CITIZENS' COMMENT FORM

Indicate Agenda Item Number: 14475 H5.

**WORLD WOODS PLANNED
DEVELOPMENT DISTRICT**

Figure 4. Cabot phase 2 Topography Map

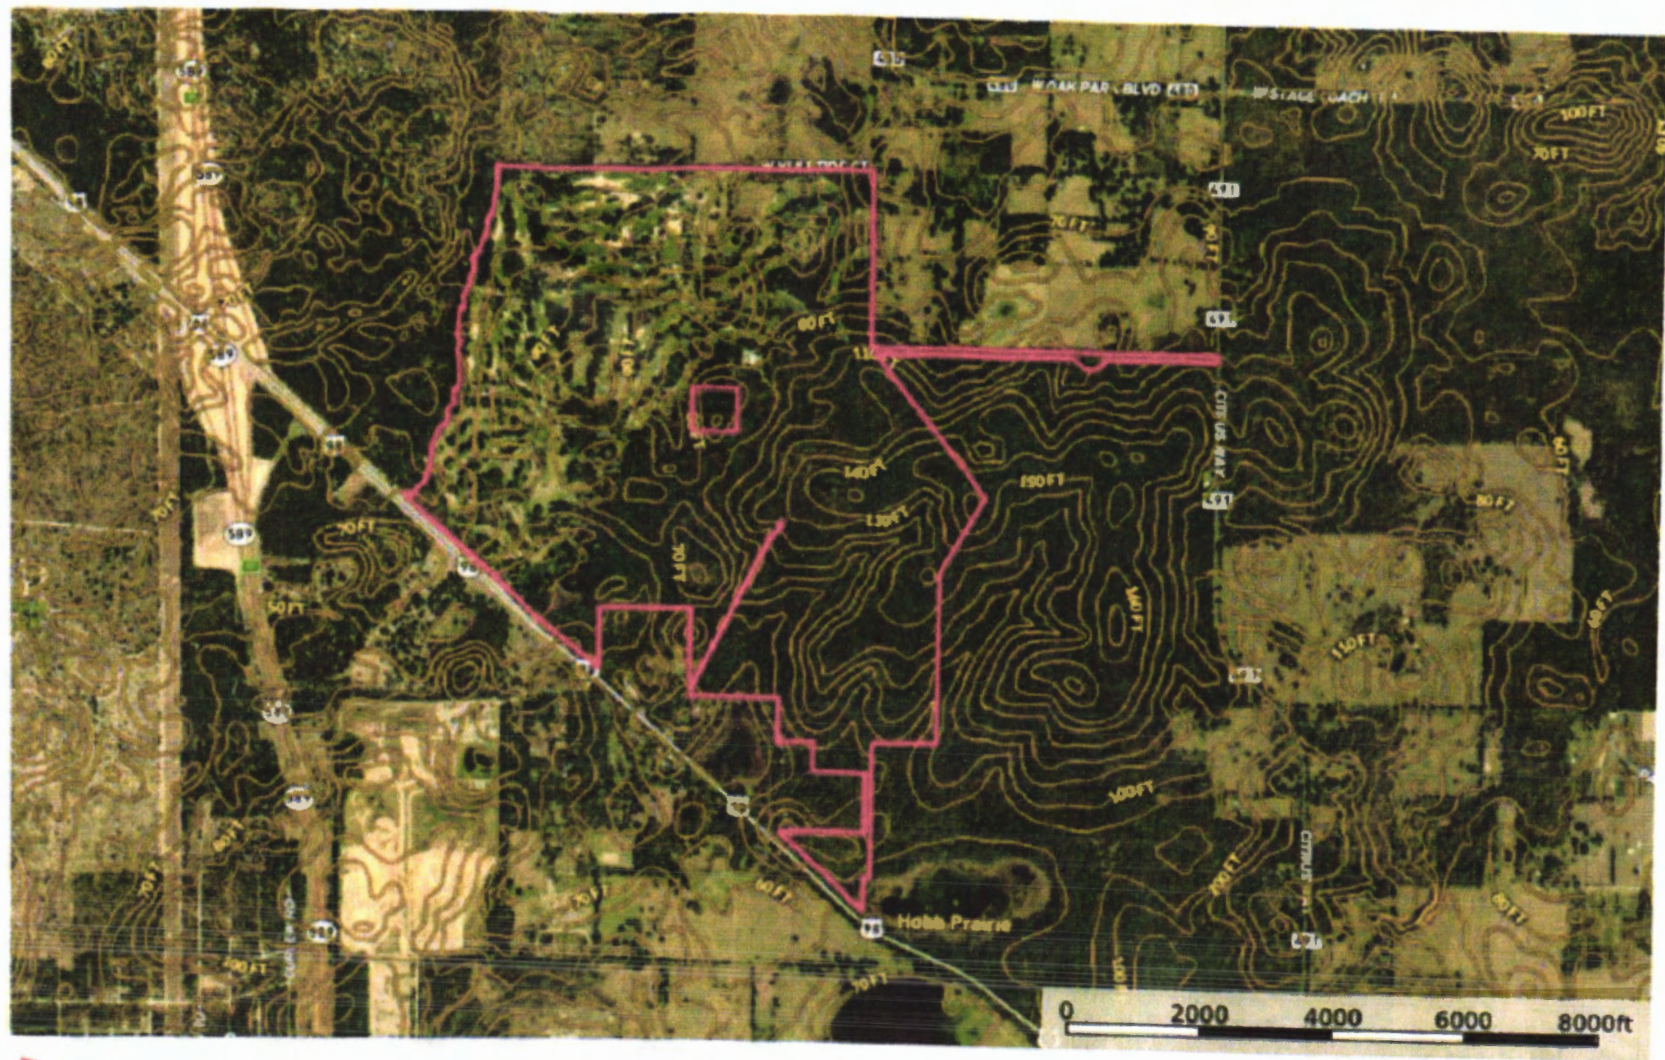
Land use
allowed in
SPA ?
